Historical Architectural Review Board
COA Preliminary Review Sheet

HDC-2026-00012

Address: 334 N. 9th Street

Proposal: Repair deteriorating brick facade

Front Elevation (Google Maps, April 2024)

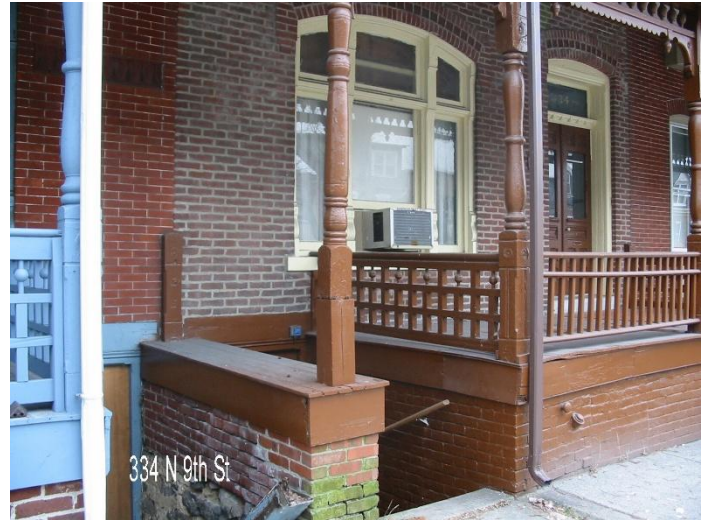
Observations & Comments: The proposed work is for the repair of the primary façade facing N. 9th street due to extensive water and structural damage related to improper mortar material. Stainless steel heli beam bars are proposed to be installed to provide structural support for the wall. Replacement brick units will match the existing in color and dimension and will be repointed with lime based mortar, which are appropriate treatments per the Guidelines. The existing front porch wall is currently painted brick; it is unclear if this area is included in the scope of work, and if the paint is intended to remain or be removed.

Discussion: The applicant clarified that the work area is on the 9th Street elevation above the porch roof; the first floor area under the roof and the brick porch foundation walls are not part of the scope of work. The applicant also noted that a previous repair had resulted in an area of stack bond, which was not the original bonding in that area, and that replacement brick would reestablish the original pattern. The HARB commended the applicant's approach to the work.

Staff Recommendation: Staff recommend approval with the following conditions:

- Brick bond matches existing configuration
- Product information for the helibeam system is submitted to staff for record, with notes about spacing/quantity of bars throughout wall.
